APPLICATION NO.	FILING DATE	FIRST NAMED INVENTOR	ATTORNEY DOCKET NO.	CONFIRMATION NO.
10/792,231	03/03/2004	Yu-Kai Lin	250122-1300	4781
24504	7590	10/19/2005	EXAMINER	
THOMAS, KAYDEN, HORSTEMEYER & RISLEY, LLP 100 GALLERIA PARKWAY, NW STE 1750 ATLANTA, GA 30339-5948			CHANDRAN, BIJU INDIRA	
			ART UNIT	PAPER NUMBER
			2835

Office Action Summary	Application No. <input checked="" type="checkbox"/>	Applicant(s)	
	10/792,231	LIN, YU-KAI	
	Examiner	Art Unit	
	Biju Chandran	2835

DETAILED ACTION

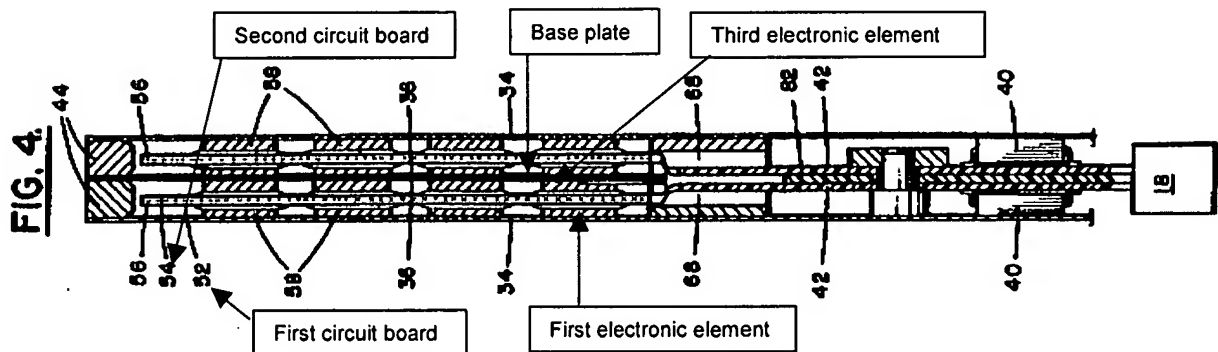
2. Claims 10-20 rejected under 35 U.S.C. 103(a) as being unpatentable over Bae in view of Cipolla et al. (US Patent 5,268,815).

- Regarding claim 10, Bae discloses all the limitations of claim 3. Bae does not disclose a second circuit board mounted between the first circuit board and the base plate with a third electronic element disposed on it. Cipolla et al. discloses a cooling mechanism for circuit board components comprising a second circuit board (54) mounted between the first circuit board (52) and the base plate (36); a third electronic element (marked in the attached figure) disposed on the second circuit board. At the time the invention was made, it would have been obvious for one of ordinary skill in the art to incorporate the

2nd circuit board with the 3rd electronic element as taught by Cippola et al. in the plasma display as disclosed by Bae, to increase the number of electronic elements that can be enclosed within the plasma display.

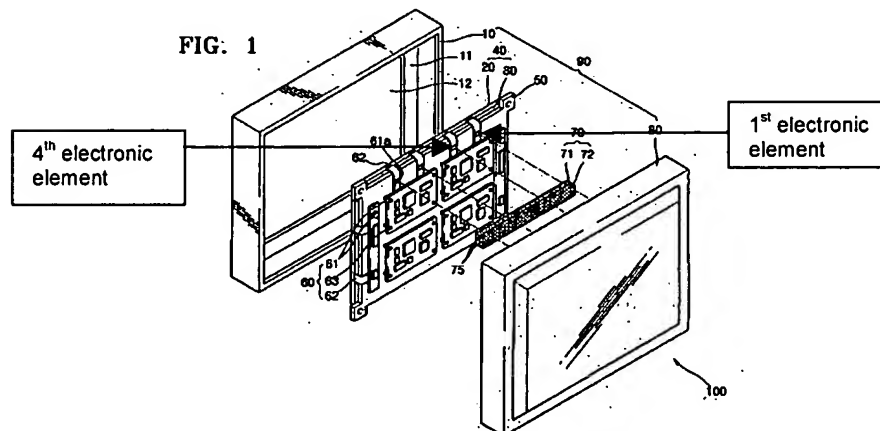
- Regarding claim 14, Bae further disclose a fourth electronic element disposed on the first circuit board (60); and a second thermal conductive device (marked in attached figure) disposed between the fourth electronic element and the back cover and mounted on the fourth electronic element (figure 4c, paragraph 0066).

- Regarding claim 19, Bae as modified by Cipolla et al. discloses all the limitations of claim 10. Cipolla et al. further disclose that the second circuit board is mounted on the base plate (see attached figure, and figure 2, Cipolla et al.). At the time the invention was made, it would have been obvious to one of ordinary skill in the art to incorporate the second circuit board mounted on the base plate as taught by Cipolla et
